## CAMELOT PARC PSLR (FKA AVALON PARK APARTMENTS) JSP22-01

Public hearing at the request of Wixom Road Development, LLC for recommendation to the City Council for Concept Plan approval under the Planned Suburban Low Rise Overlay District. The subject property is located on the east side of Wixom Road, north of Eleven Mile Road (Section 17). The applicant is proposing 46 apartment units in three low-rise buildings. The subject property is currently zoned R-1, One Family Residential, with a Planned Suburban Low-Rise Overlay.

Recommend approval/denial of the Planned Suburban Low-Rise (PSLR) Overlay Concept Plan to the City Council.

**LP-3**

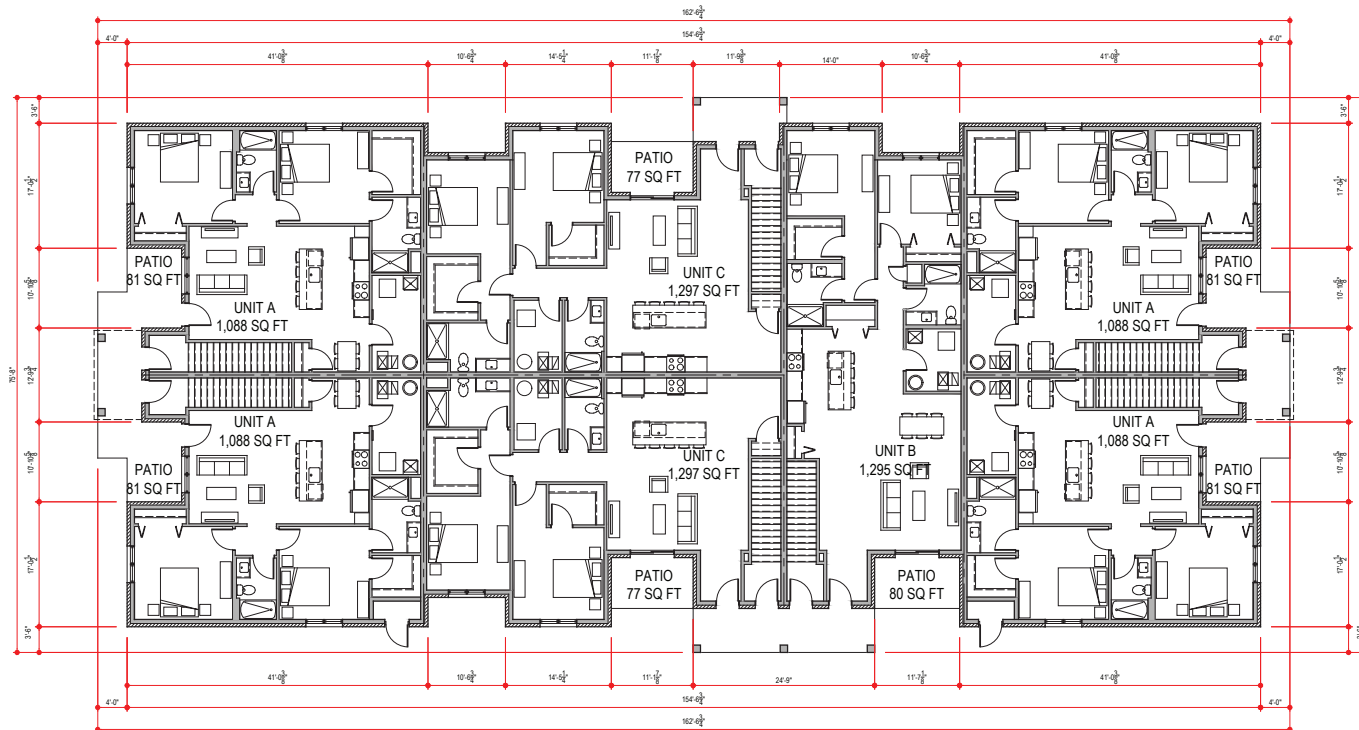
**REQUESTED LANDSCAPE WAIVERS:**  
Wixom Road: Berm / Wall, Buffer & Street Trees adjacent to Public ROW  
REQUEST: Maintain existing natural trees and woodlot north of the emergency access drive in lieu of installing the required berm which would require the removal of the existing trees and woodlot.  
REQUEST: Maintain existing natural trees and vegetation north of the emergency access drive in lieu of installing the required landscaping and trees plantings.  
Calculations shown on Sheet LP-1 have been adjusted to account for this Waiver Request

**Response: See sheet LP-3 for foundation planting plan.**

**Response: A foundation planting plan is included on sheet LP-3.**

**Figure 1. Avalon Park Townhomes Site  
 City of Novi Regulated Woodland Map**  
 Blue line = parcel boundary  
 Green hatched areas = City of Novi regulated woodland map  
 Yellow Circle = General area determined to be regulated woodland

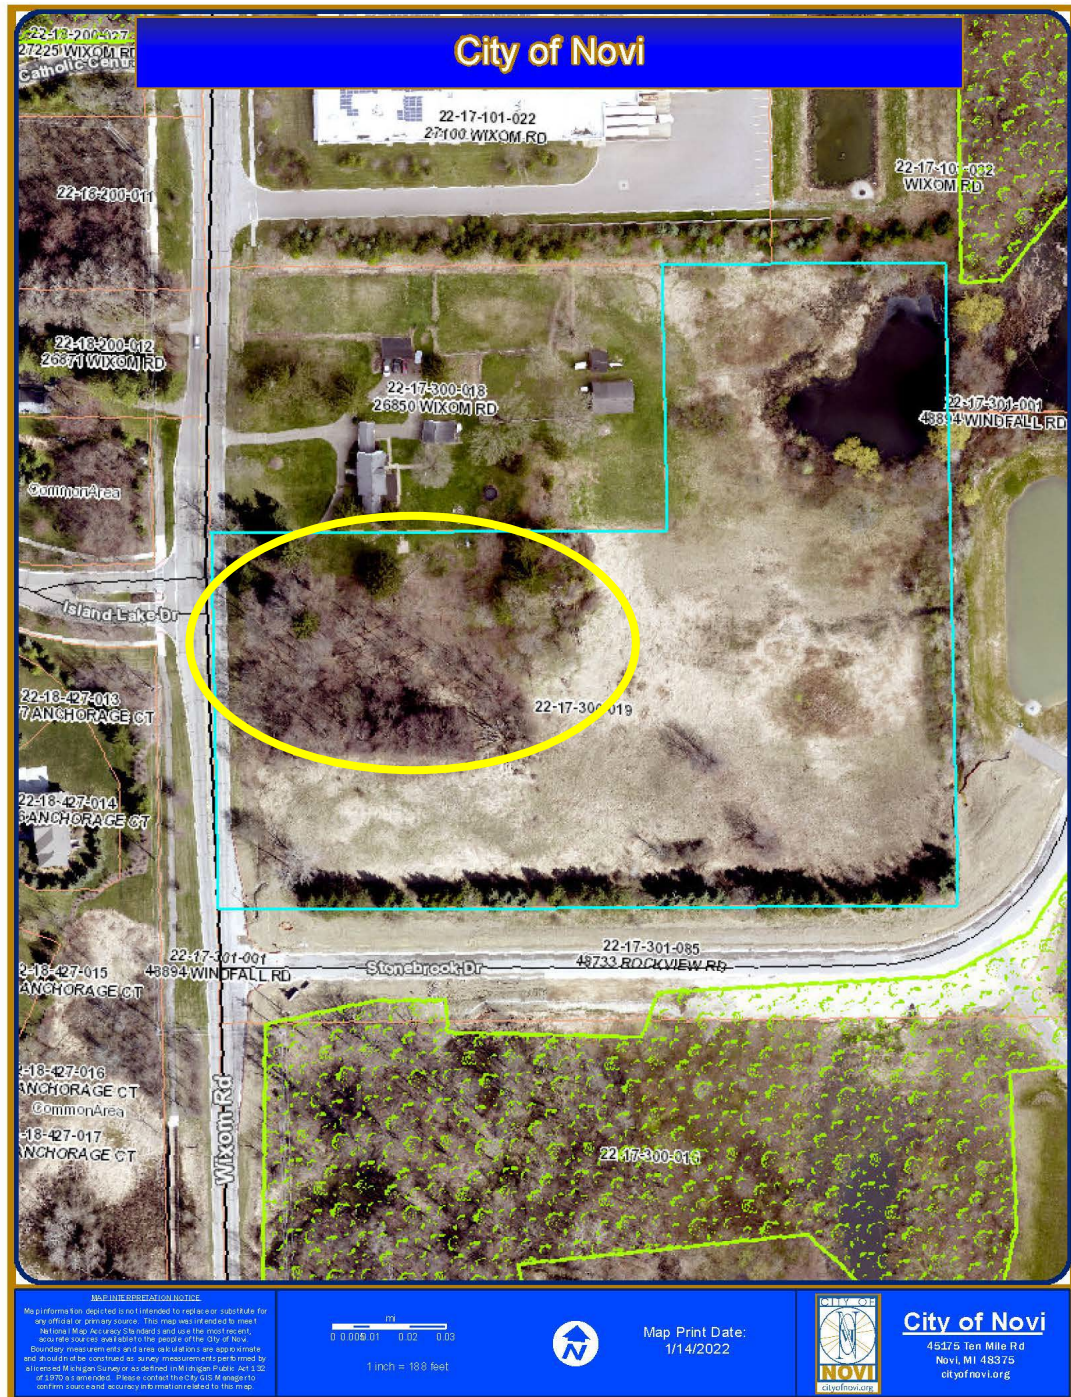
3. **Woodland Replacements (Sheet 9 and Sheet LP-2).** The site is required to mitigate the removal of the

The Plan (Sheet LP-2) proposes the planting of **the 40 replacement credits on-site** by planting the following:
